ORDER UNDER SECTION 96 (2) OF ACT, III OF 1901.

_____ on plot No. 259 Survey Sheet 61

PROPOSED BUILDING ON PLOT NO. 259 SHEET NO. E.1.

JAIL QUARTER — SCALE 8 FT. TO AN INCH

PLAN OF GROUND FLOOR

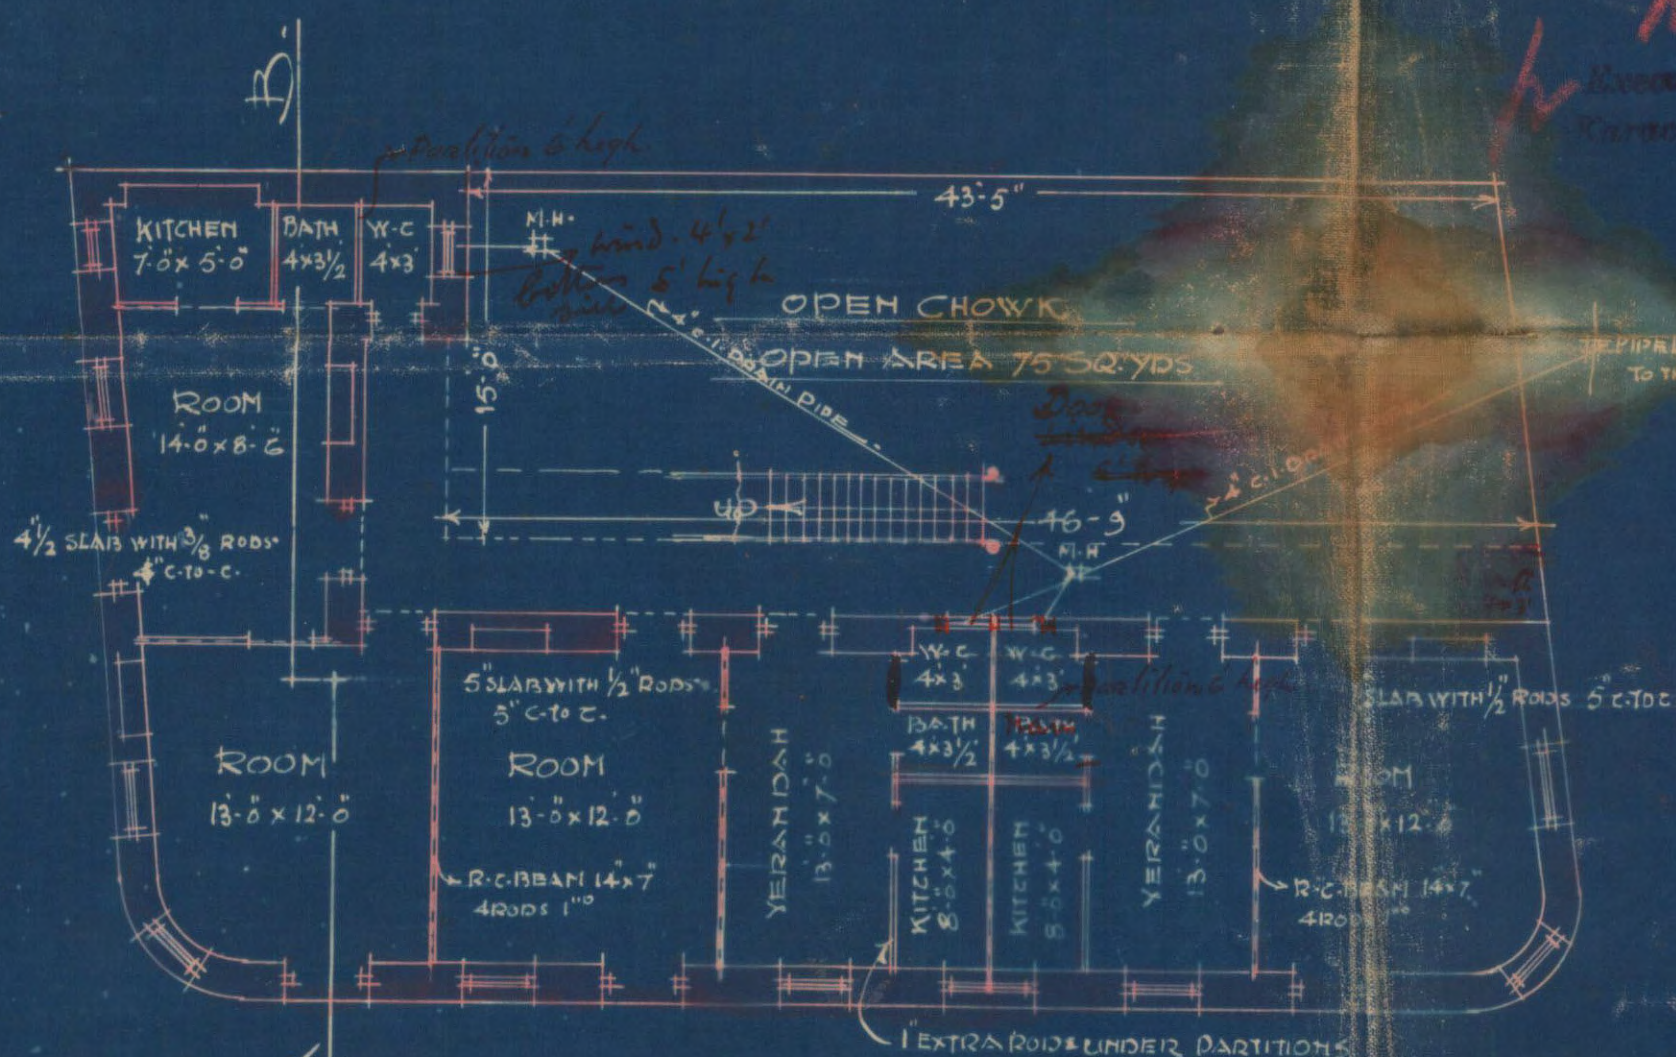
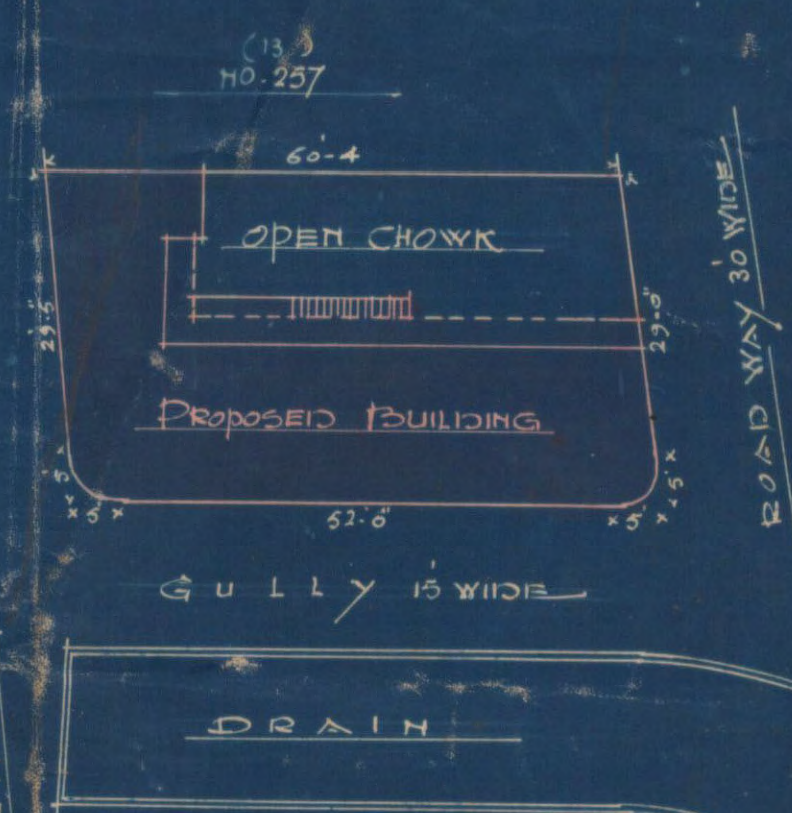
(1) Stair is not permissible in the open space

(2) Foundation Courses are not dimensioned.

(3) Plinth height - should be 2' ^{at least} and marked on the plan

(4) For 12' span, the R.C. slab may be made 6" thick
with $\frac{1}{2}$ " rods 6" c.c.

- (1) open space is less than one third the area of plot by about 25 sq. yds as the gallery projects into the open space.
- (2) The area of plot, area of building and open area must be written down on the plan.
- (3) Extra steel must be provided beneath partition walls of kitchen.
- (4) Projection of cornice should not be more than 1 foot beyond plinth.
- (5)
- (6)
- (7)
- (8)
- (9)

- (1) Width of open space for a height of 36 feet must be 14' min. while it is only 9'-9" as the proposed for the plan.
- (2) Extra steel must be provided beneath partition wall of kitchen.
- (3) Projection of cornice should not be more than 1' beyond plinth.
- (4) Open space is less than $\frac{1}{3}$ the area of the plot by about 25 sq yds. The area of the plot, built-up area and open area must be clearly written down on the plan.

PLOT AREA 224 SQ. YDS.
BUILDING AREA 149 SQ. YDS.
OPEN AREA 75 SQ. YDS.
TOTAL AREA 224 SQ. YDS.

PLAN OF FIRST & SECOND FLOORS

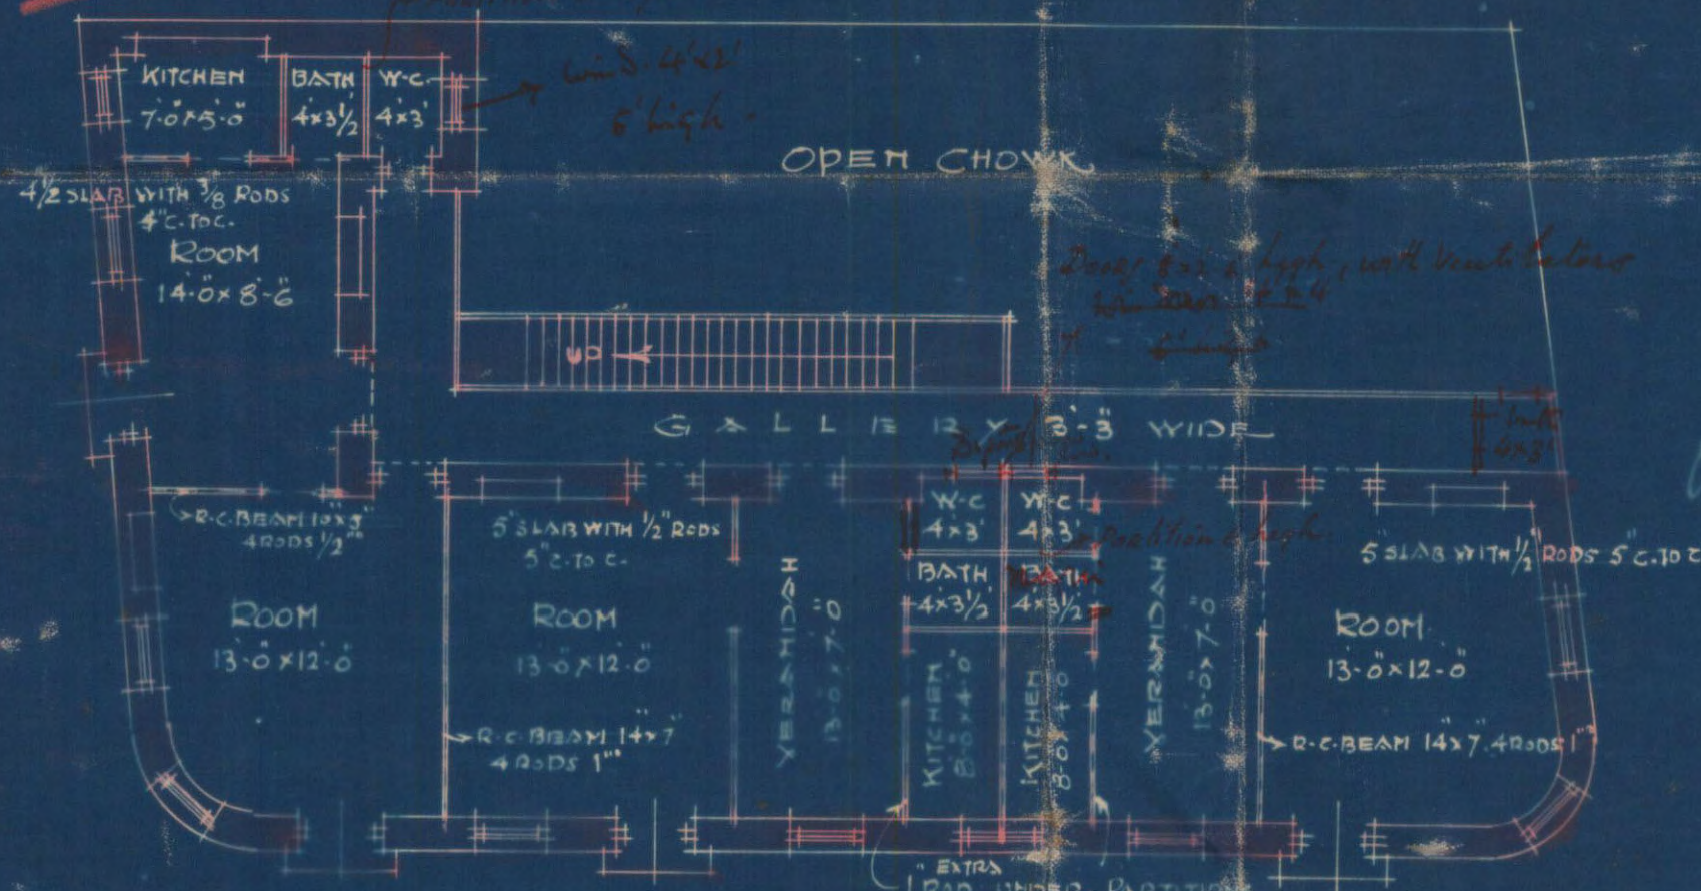
- (1) W.C. must have entrance from the gallery
- (2) and be cut off from the verandah by a dead wall
- (3)
- (4)
- (5)
- (6)
- (7)
- (8)
- (9)

W. C. Kler must have entrance from the gallery & be
cut off from the Veranda by a dead wall

With reference to your memo No. 4331 dated 11th instant we very much regret that after complying with all your requirements and settling all the points in your office the plans should be returned to us with fresh objections. We do not see any objection to the doors of the W.C.s opening in the ~~passage~~ ^{re-entrance}. However we have consulted our client and he has agreed to give an access to the W.C.s from the gallery.
